*ADDENDUM NO. 1*

*NOTAWASEPPI HURON BAND OF THE POTAWATOMI*

*RECREATION FACILITIES PROJECT*

Addendum No. 1 to the plans and specifications for the Notawaseppi Huron Band of the Potawatomi, Recreation Facilities Project as prepared by Wightman & Associates, Inc., dated August, 15, 2011.

APPROVED BY: *MATT DAVIS*  
 DATE: AUGUST, 2011  
 SCALE: 1" = 20'  
 DRAWN BY: H.J.C. CHECKED BY: *SND*  
 JOB NO. 110142 SK-1

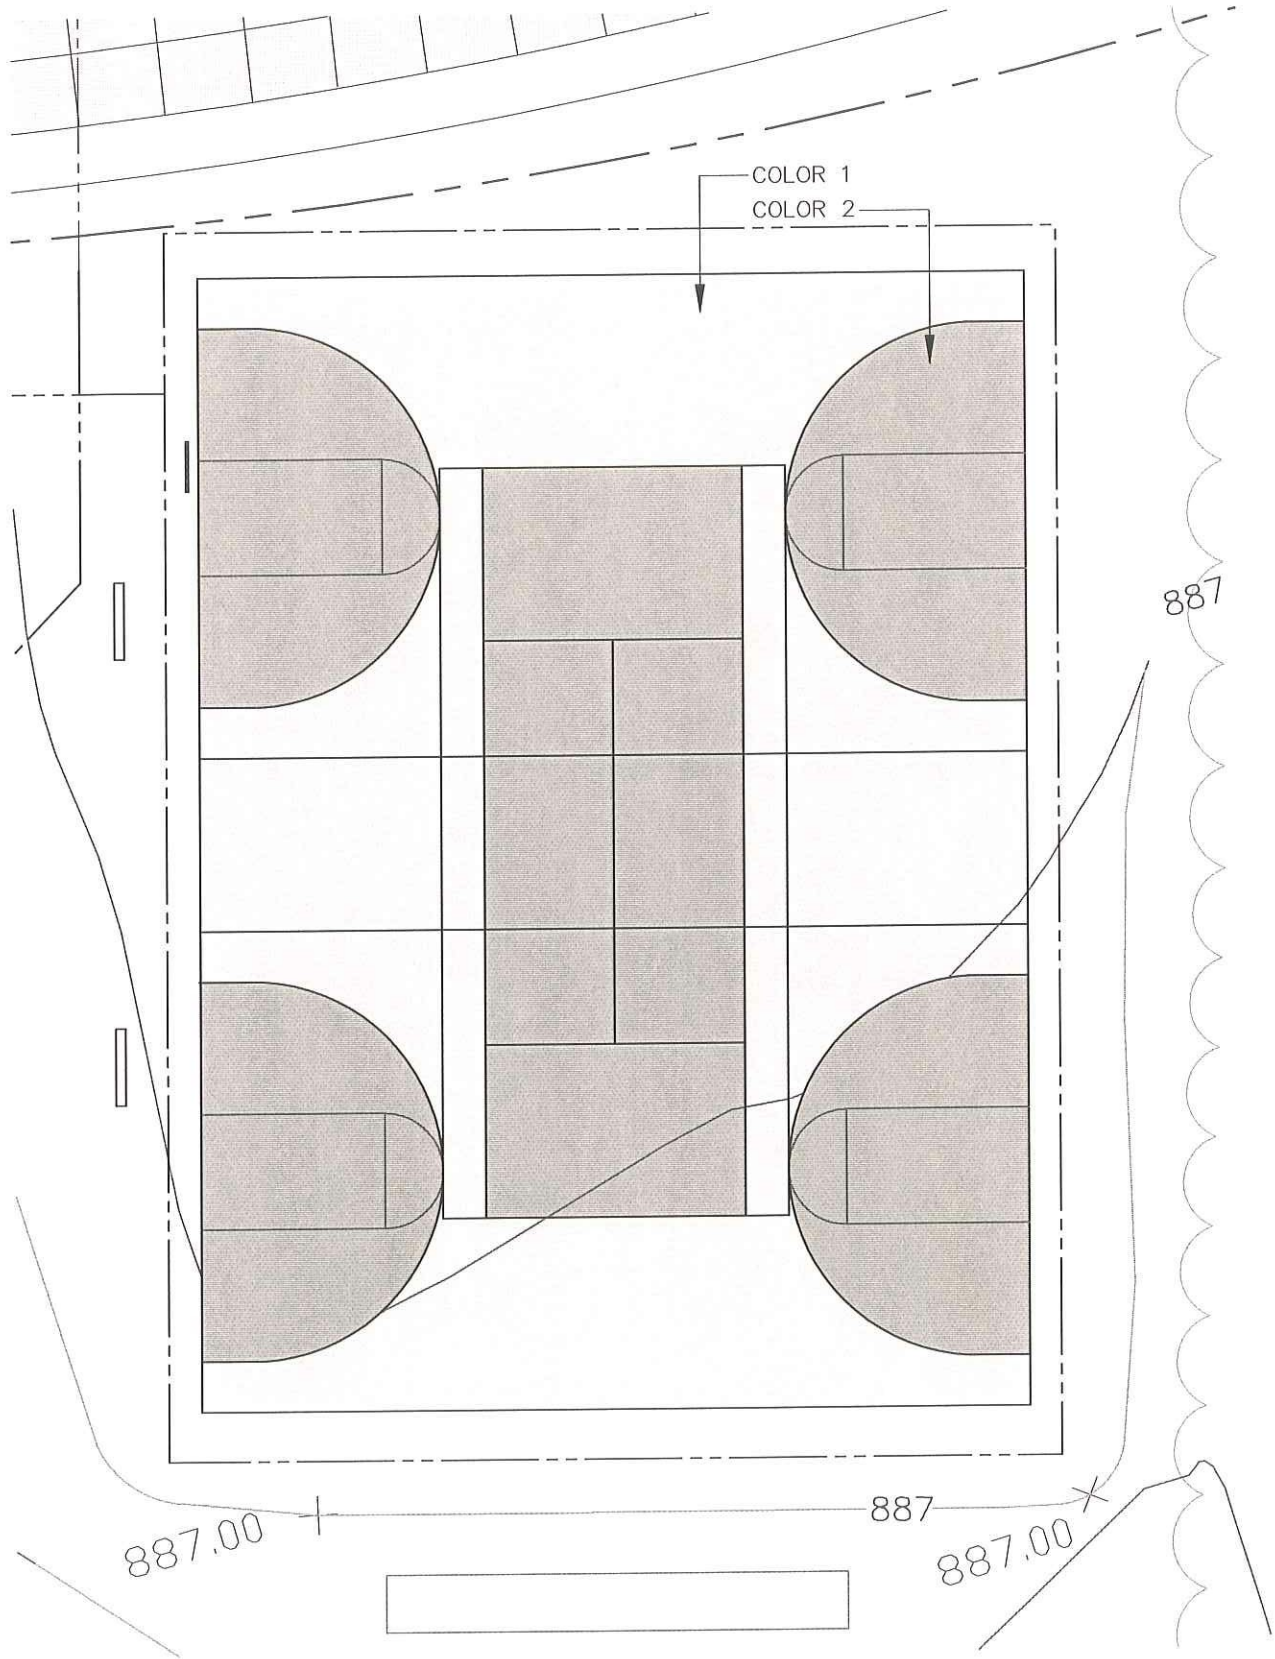
- F) Under the Alternate 3B – Colored Concrete, layout information for the integral coloring of the concrete has been provided on Sketch Add. 1. The basketball/tennis court shall be widened by 2', dimensions shall be 124'x90'.
- G) Under Note 19 on Drawings 110142-01, the following shall be added: "Topsoil shall be screened using a minimum screen size of 5/8"x5/8". Stockpile rock debris onsite as directed by the Engineer."
